# Citify and BFC Pty Ltd C/- Future Urban Group

# 248 Unley Road, Hyde Park

090/M005/18

#### **OVERVIEW**

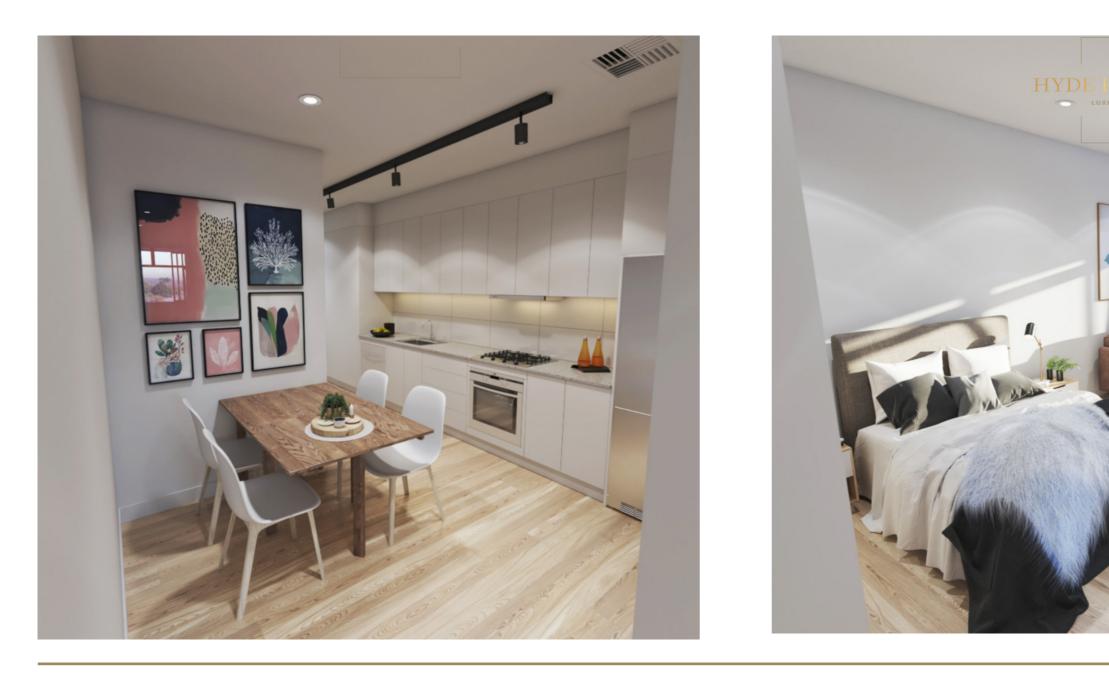
"I am concerned about the depth of the open plan space of the studio apartments (TypeH), where the rear of the dining area is approximately 9.5m from the only window and the kitchen area has no access to natural light."

The size of the opening (sliding doors) from these apartments is 8.5m<sub>2</sub>. This, according to the BCA, provides sufficient light for 85m<sub>2</sub>. The habitable areas of the studios (excluding the galley kitchen) is less than 30m<sub>2</sub>.
